Second Semi-Annual Report

**Frontier Chemical - Pendleton Site
Town of Pendleton,
Niagara County, New York**
[REDACTED]

Subject: Frontier Chemical - Pendleton Site, Pendleton, New York
Order on Consent (#B9-0270-89-05)
Semi-Annual Report on Post Closure Operation, Maintenance, and Monitoring
Activities, March 1998

FIGURE 1

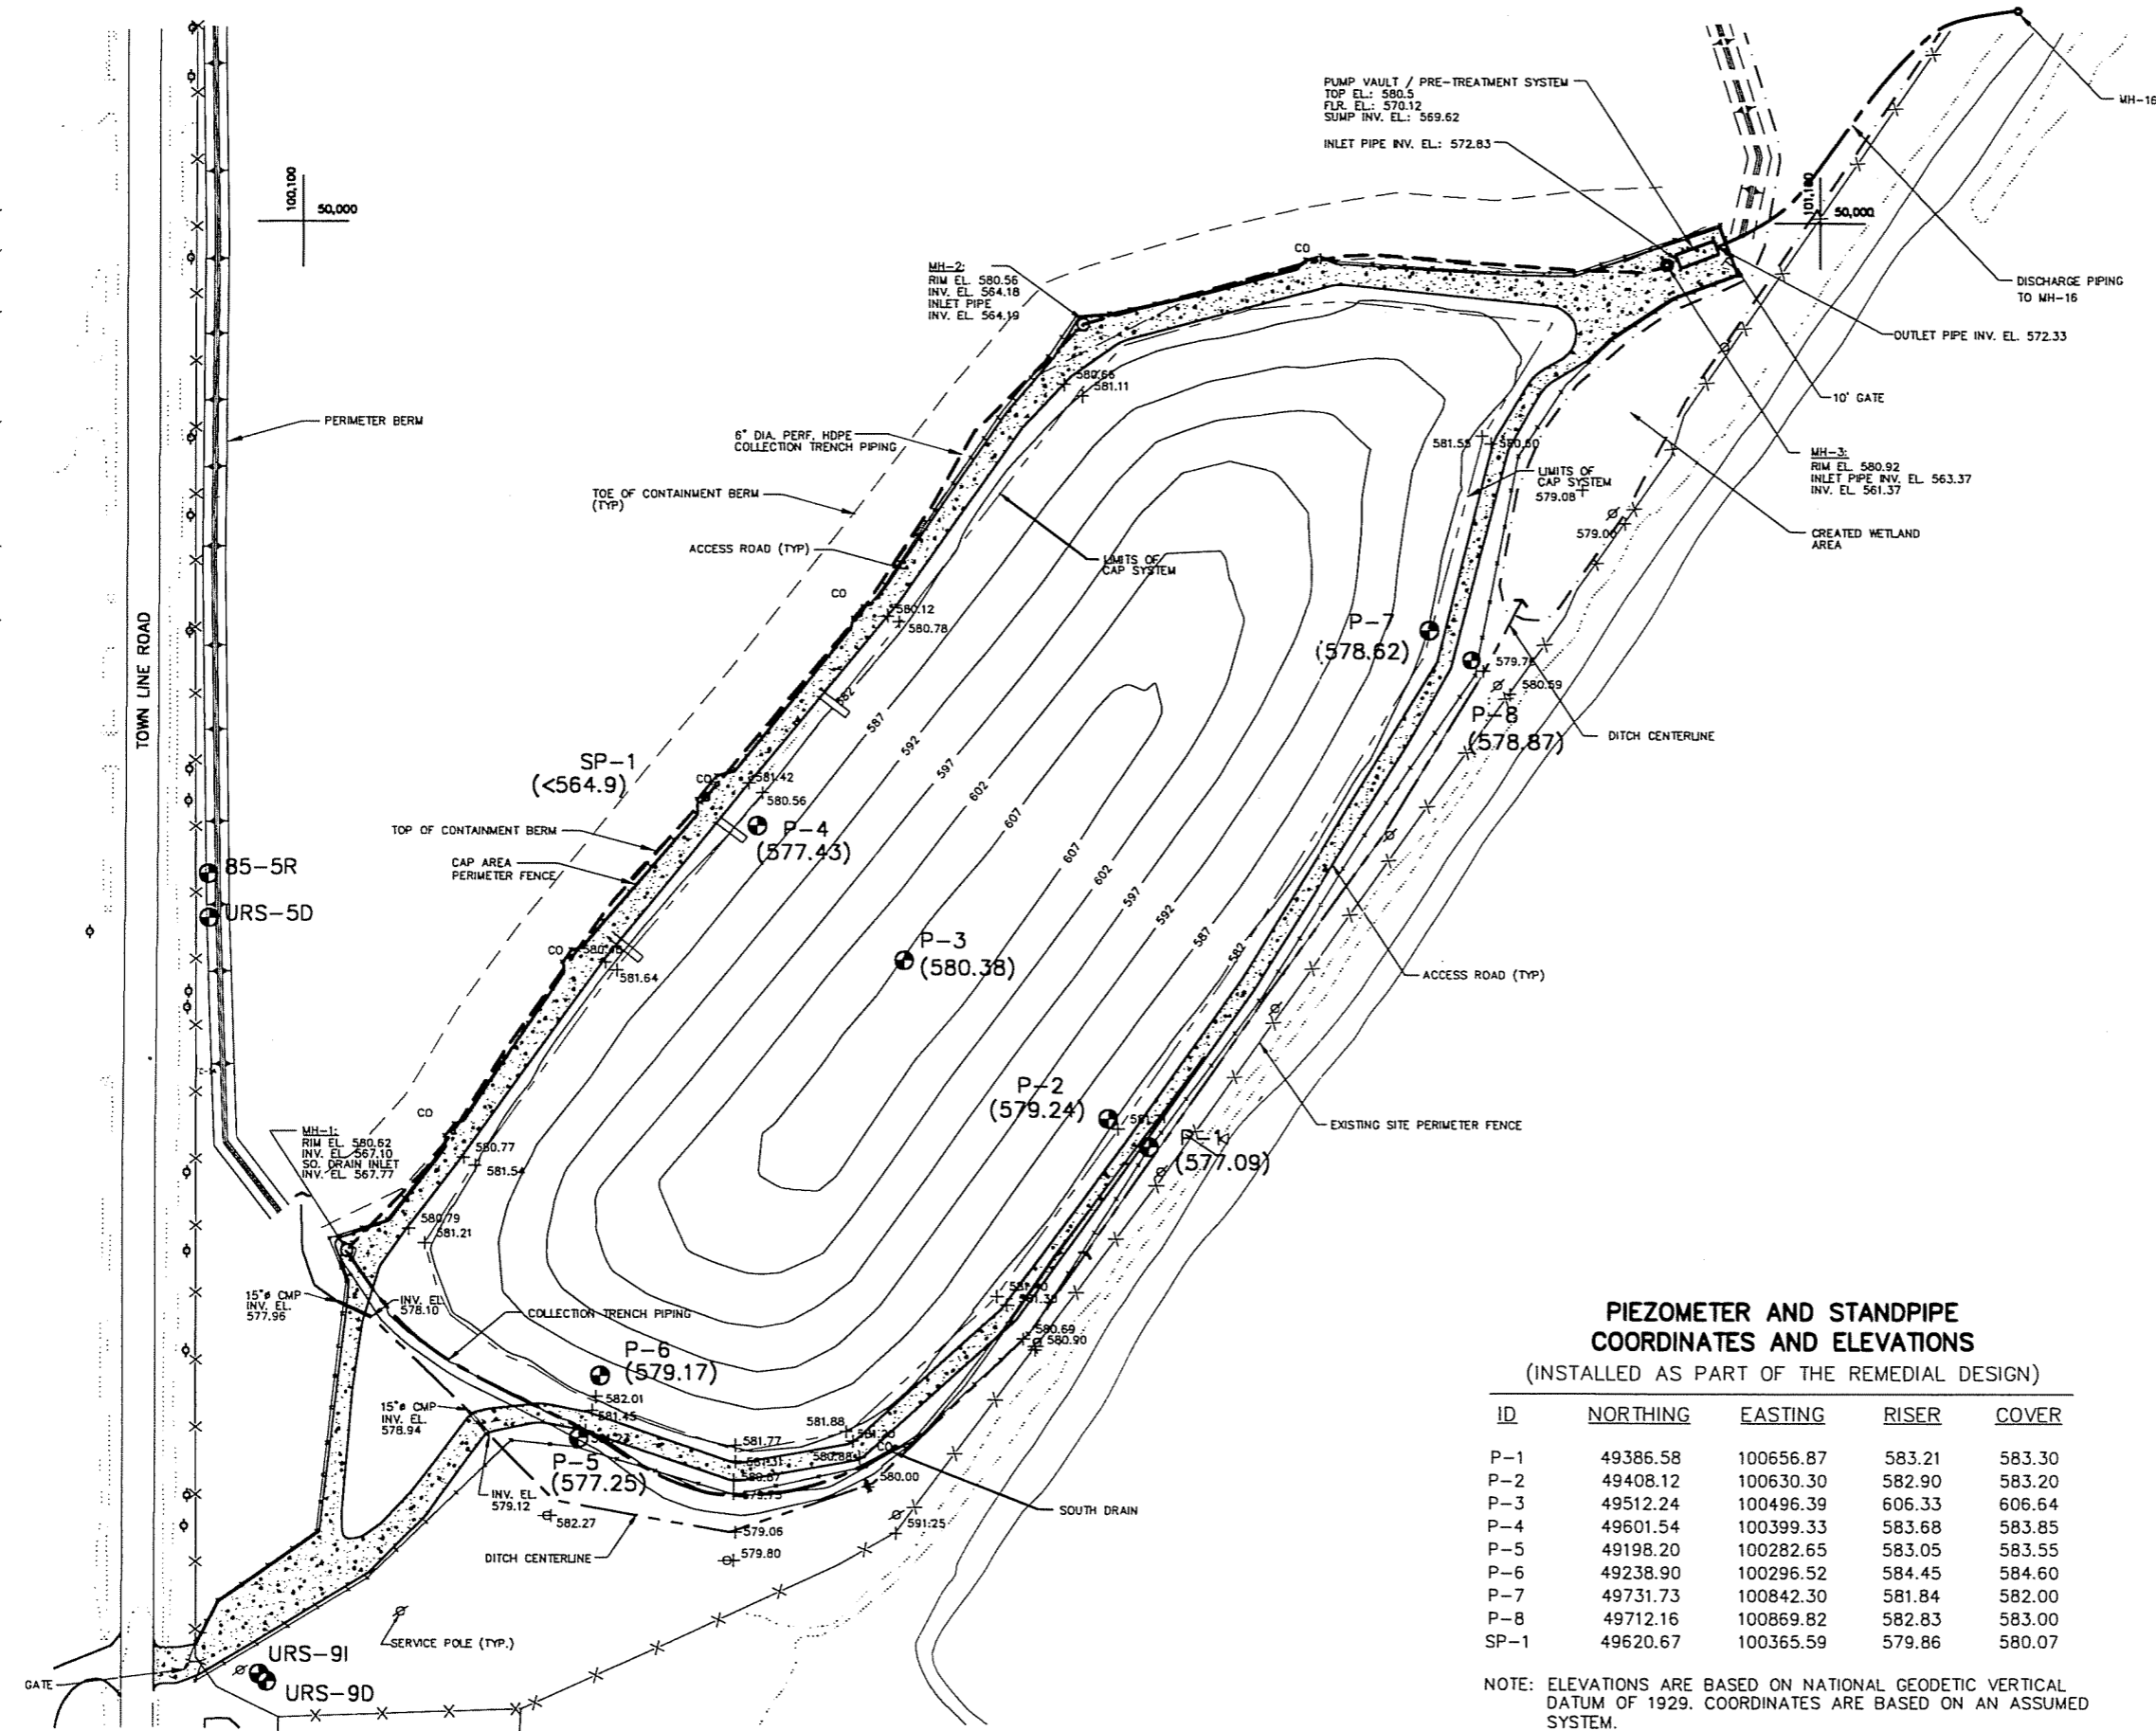
Comment 5. Figure 1, indicate the ground water level measurements taken from the monitoring wells and the lake water level in the same manner as indicated for the piezometers.

Response: All level measurements are included on Figure 1.
